# Access Compliance Report

## Public Rights-of-Way

Intersection ID: 11685	Main Street: E_19TH_ST	Cross Street: SEIGLE_AV	Location: W
ADA ID: F1D1CDC8C13D	Ramp Type: Perp	Initial Pass/Fail: Fail	Overall Compliance: No
Severity Score: 21.25			
Codes/Mitigation Info/Possible Solution		Field Measurements/Component Compliance

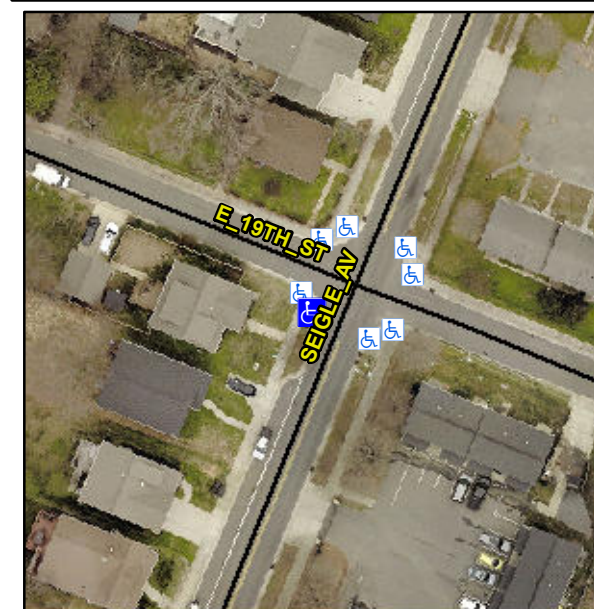
**Not Found, R304.5.1, R304.5.3**

Compliance	Description	Data	Compliance	Description	Data
N/A	Ramp Length (in)	64.0	Yes	Ramp Slope (%)	7.3
No	Ramp Width (in)	47.5	No	Ramp XSlope (%)	6.6
N/A	Flare Type LT	N/A	N/A	Flare Type RT	N/A
N/A	Flare Slope LT (%)	N/A	N/A	Flare Slope RT (%)	N/A
N/A	Flare Traversable LT?	N/A	N/A	Flare Traversable RT?	N/A
N/A	Landing Length (in)	N/A	N/A	DWS Provided?	N/A
N/A	Landing Width (in)	N/A	N/A	DWS Contrast?	N/A
N/A	Landing Slope (%)	N/A	N/A	DWS Length (in)	N/A
N/A	Landing X Slope (%)	N/A	N/A	DWS Full Width?	N/A
N/A	Landing Curb? (Y/N)	N/A	N/A	DWS Offset (in)	N/A
N/A	Shared Landing?	N/A			
N/A	Gutter Ponding?	N/A	N/A	Gutter Slope (%)	N/A
N/A	Gutter Lip Ht (in)	N/A	N/A	Gutter X Slope (%)	N/A
N/A	Painted X Walk1?	No	N/A	Painted X Walk2?	N/A
	X Walk 1 Direction	To SE		X Walk 2 Direction	N/A
N/A	X Walk 1 Width (in)	N/A	N/A	X Walk 2 Width (in)	N/A
	X Walk 1 Slope (%)	5.8		X Walk 2 Slope (%)	N/A
	X Walk 1 X Slope (%)	2.7		X Walk 2 X Slope (%)	N/A

**Remove & Replace Entire Ramp.**
